REQUEST FOR COUNCIL ACTION

Item Description: Request for Approval of a Preliminary Plat at 2201 Acorn Road

REQUEST FOR PLANNING COMMISSION ACTION

Item Description: Request for approval of a preliminary plat at 2201 Acorn Road (PF15-023)

EXISTING CONDITIONS SURVEY AND PRELIMINARY TREE INVENTORY AND TREE REMOVAL PLAN

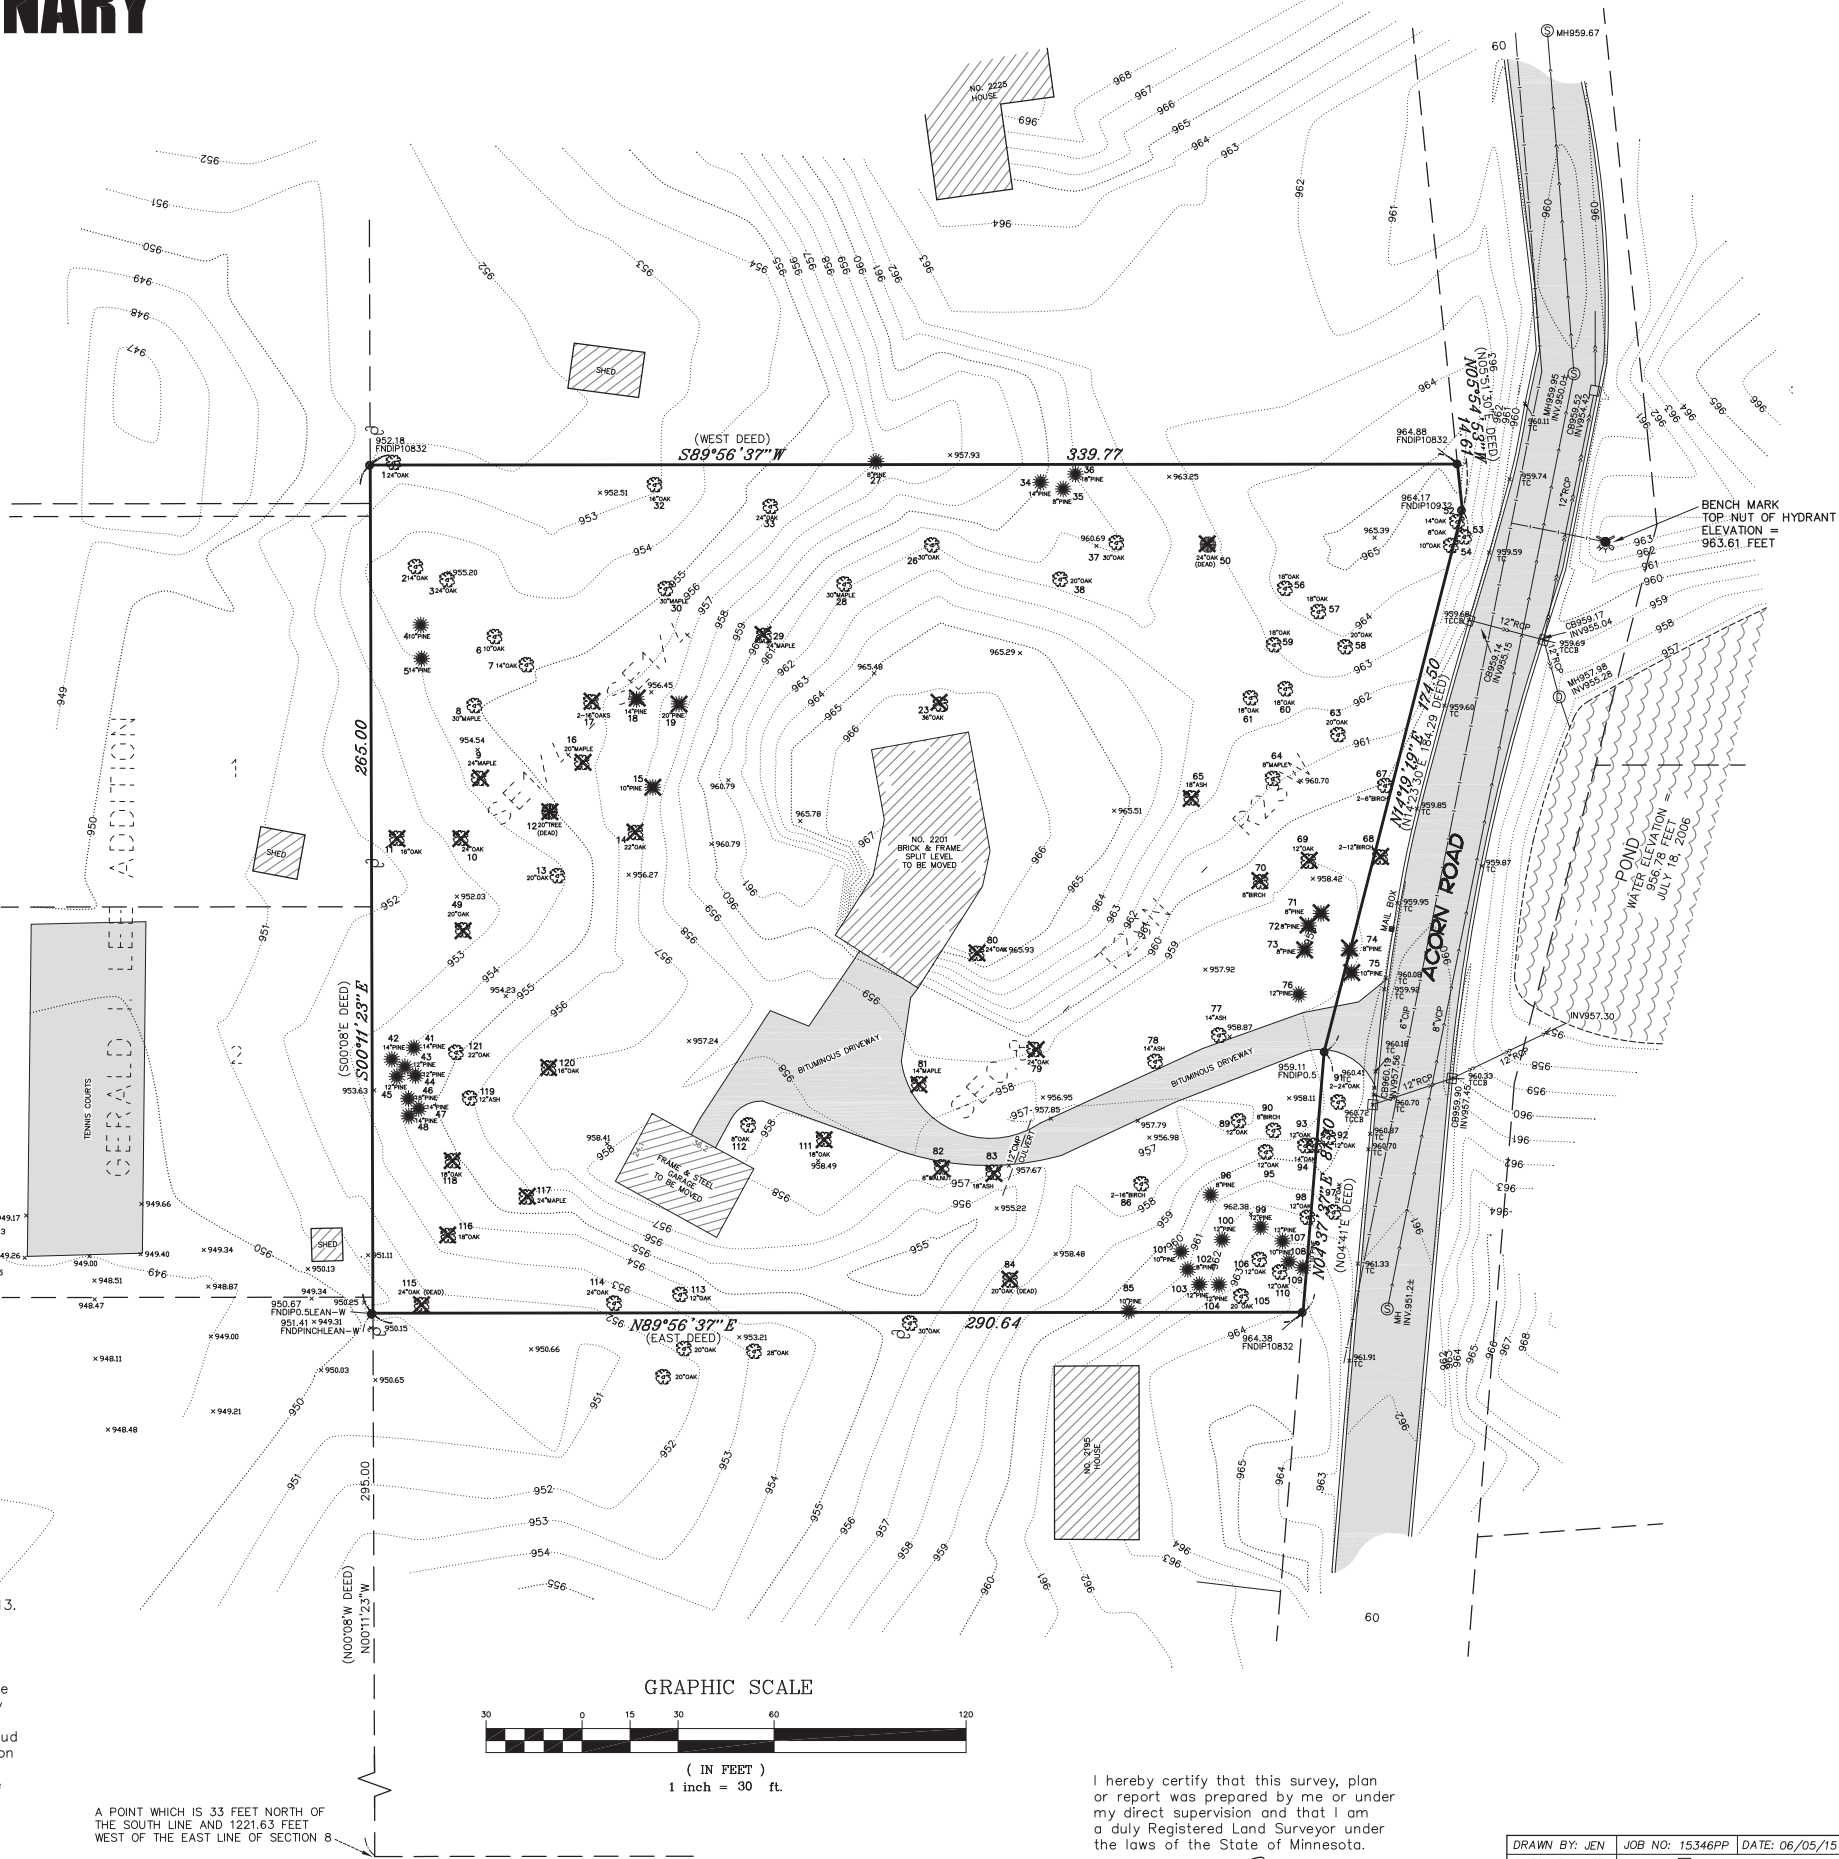
Member Murphy asked staff for a comparison with this latest tree removal plan with that of the most recent past iteration.

- 4) The project's proposed grading design does not provide adequate assurance that trees intended to remain on the property, in accordance with the City's tree preservation policy, will survive in the long-term due to their close proximity to said grading.

City Code specifies that an approved tree preservation plan is a necessary prerequisite for approval of a preliminary plat. Mark Rehder, the certified arborist consulting with the Community Development Department, has reviewed the submitted tree preservation plan and determined it to be an accurate inventory of existing trees as well as a reasonable assessment of the trees likely to be lost as a result of the proposed development. The plan indicates the expected removal of 23 significant- and heritage-size deciduous trees and eight significant coniferous trees; based on the tree replacement calculations in the City Code, this would not require planting replacement trees beyond what is called for in the landscaping of new one-family, detached residences. Mr. Rehder will continue to review the plan for on-going accuracy as development plans are finalized and will monitor tree removal and protection efforts during construction.

Mr. Lloyd briefly reviewed the tree preservation reviewed by the City's tree consultant Mark Rehder, S & S Tree Service, with monitoring continuing as the project proceeded.
